METROPOLITAN GOVERNMENT OF NASHVILLE AND DAVIDSON COUNTY

STAFF RECOMMENDATION 3109 Acklen Avenue November 19, 2014

Application: New construction-infill
District: Hillsboro-West End Neighborhood Conservation Zoning Overlay
Council District: 18
Map and Parcel Number: 10410018100
Applicant: Ben and Bonnie Whitehouse
Project Lead: Paul Hoffman, paul.hoffman@nashville.gov

Figure 2. Site plan of new buildings. The existing house on the site is shown straddling the new lot line.

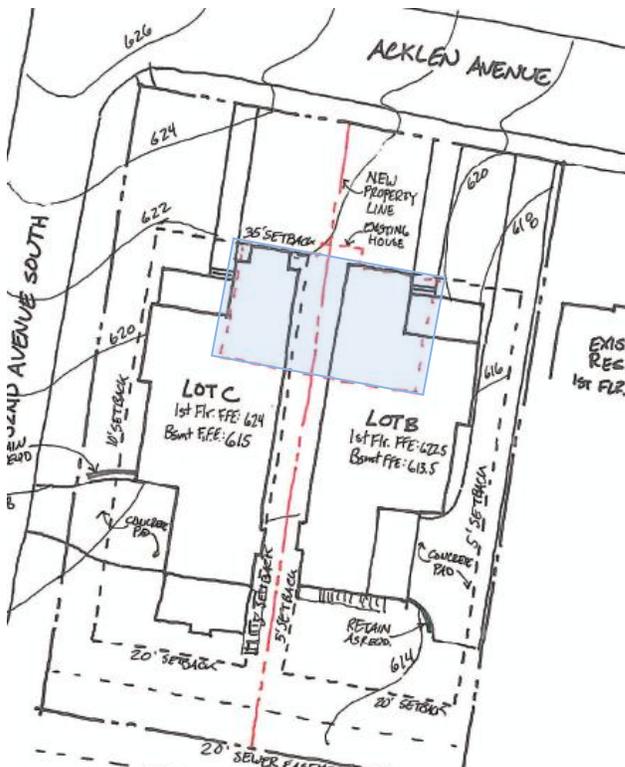
The infill for Lot B, the interior lot, has side setbacks of eleven feet (11') and five feet (5') from the side property lines and forty-four feet (44') from the rear. A chimney protrudes two feet (2') into the setback area to the inside. This is a permitted setback obstruction. The front setback is thirty-five feet (35') which maintains that of the neighboring contributing homes on this side of Acklen Avenue.

Lot C, the corner building, has similar side setbacks of eleven feet (11') from 32nd Avenue South, and five feet (5') from the interior property line. This meets setbacks requirements of five feet (5') on the inside, and ten feet (10') from 32nd Avenue South. This home also includes a chimney in the side setback area, and this is a permitted setback obstruction.

The proposed infill will maintain the setback and rhythm of spacing on Acklen Avenue, and meets section II.B.1.c.
